Access Compliance Report

Public Rights-of-Way

(Pedestrian Signals)

Intersection ID: N/A	Main Street:	Cross Street: N/A	Location: N/A
ADA ID: ED18A9232592	Signal Type: One Push Button-Non APS	Overall Compliance: No	Severity Score: BTN 1: N/A BTN 2: N/A No BTN: N/A
Codes/Mitigation Info/Possible Solution		Field Measurements/Component Compliance

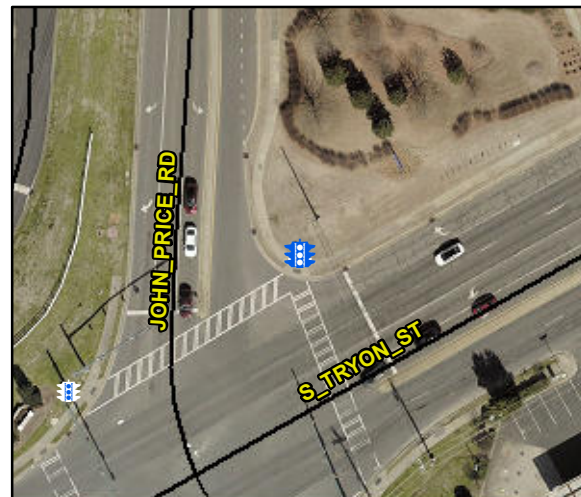
Possible Solutions: Replace Signal Push Button With APS Button on New Post. Remove & Replace Sign.

PROW/ADA: R410.6, TMUTCD 4e.08, R404.2, R406.2

Compliance	Description	Data	Compliance	Description	Data
	Button Count	Button1	N/A	Distant to Additional Button (in)	N/A
	Additional Button Present?	No		Additional Button ID	N/A
N/A	Signal Buttons Required?	N/A	N/A	Additional Ped Posts Required	N/A
	How Many Ped Street Xings?	2		Located In An Island/Median?	No
N/A	B 1 Sign Present?	Yes	N/A	B 2 Sign Present?	N/A
Yes	B 1 Sign Purpose?	Yes	N/A	B 2 Sign Purpose?	N/A
No	B 1 Sign Lettering & Contrast?	No	N/A	B 2 Sign Lettering & Contrast?	N/A
Yes	B 1 Parallel To XWalk?	Yes	N/A	B 2 Parallel To XWalk?	N/A
Yes	B 1 PAR to Button?	Yes	N/A	B 2 PAR to Button?	N/A
Yes	B 1 PAR to XWalk?	Yes	N/A	B 2 PAR to XWalk?	N/A
Yes	B 1 Clear Floor Space?	Yes	N/A	B 2 Clear Floor Space?	N/A
N/A	B 1 FWD Approach?	Yes	N/A	B 2 FWD Approach?	N/A
N/A	B 1 FWD Approach Constrained?	No	N/A	B 2 FWD Approach Constrained?	N/A
No	B 1 FWD Approach Reach (in)	12.0	N/A	B 2 FWD Approach Reach (in)	N/A

N/A	B 1 FWD Approach Width (in)	N/A	N/A	B 2 FWD Approach Width (in)	N/A
N/A	B 1 FWD Approach Obstruction?	Yes	N/A	B 2 FWD Approach Obstruction?	N/A
N/A	B 1 FWD Approach Obstruction Dist (in)	3.0	N/A	B 2 FWD Approach ObstructionDist (in)	N/A
N/A	B 1 PARA Approach?	Yes	N/A	B 2 PARA Approach?	N/A
N/A	B 1 PARA Approach Constrained?	No	N/A	B 2 PARA Approach Constrained?	N/A
Yes	B 1 PARA Approach Reach (in)	9.0	N/A	B 2 PARA Approach Reach (in)	N/A
N/A	B 1 PARA Approach Width (in)	N/A	N/A	B 2 PARA Approach Width (in)	N/A
N/A	B 1 PARA Approach Obstruction?	Yes	N/A	B 2 PARA Approach Obstruction?	N/A
N/A	B 1 PARA Approach Obstruction Dist (in)	6.0	N/A	B 2 PARA Approach ObstructionDist (in)	N/A
Yes	B 1 Clear Floor Space Slope (%)	2.0	N/A	B 2 Clear Floor Space Slope (%)	N/A
No	B 1 Clear Floor Space XSlope (%)	2.3	N/A	B 2 Clear Floor Space XSlope (%)	N/A
N/A	B 1 PAR Slope (%)	6.9	N/A	B 2 PAR Slope (%)	N/A
Yes	B 1 Height (in)	36.0	N/A	B 2 Height (in)	N/A

Yes	B 1 Clear Xing Direction?	ClearlyMarked	N/A	B 2 Clear Xing Direction?	N/A
	B 1 Crossing Direction	To SE		B 2 Crossing Direction	N/A
Yes	B 1 DistanceTo XWalk (in)	43.0	N/A	B 2 DistanceTo XWalk (in)	N/A
No	B 1 DistanceTo Curb (in)	102.0	N/A	B 2 DistanceTo Curb (in)	N/A
Yes	B 1 Diameter (in)	2.0	N/A	B 2 Diameter (in)	N/A
